XJ100-12

TECHNICAL BULLETIN

Transit Relay Removal – Change In Procedure

MODEL 2006 MY-ON XJ range

ILLUSTRATION 1

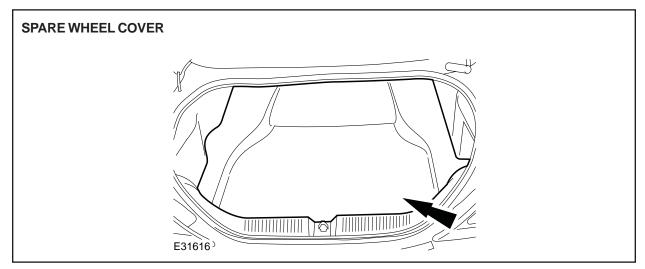
- 1. Ensure the ignition is switched 'OFF'.
- 2. Open the luggage compartment.
- 3. Remove the spare wheel cover (Illustration 1).

ILLUSTRATION 2

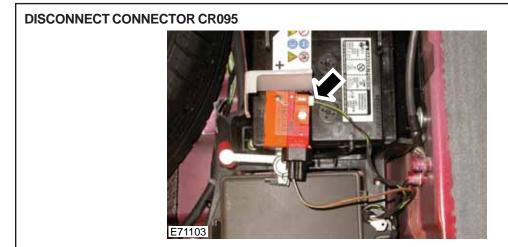
4. Disconnect white electrical connector (CR095) from the transit relay (Illustration 2).

ILLUSTRATION 3

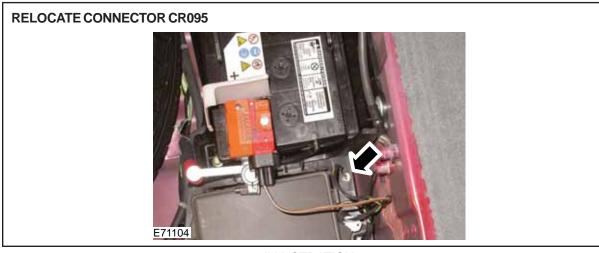
5. Locate the white electrical connector (CR095) into the battery tray (Illustration 3).

ILLUSTRATION 6

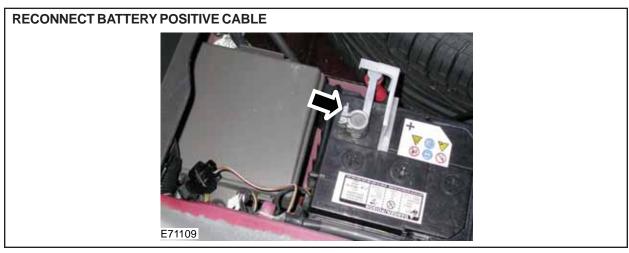
8. Loosen the two transit relay securing bolts, and remove the transit relay (Illustration 6).
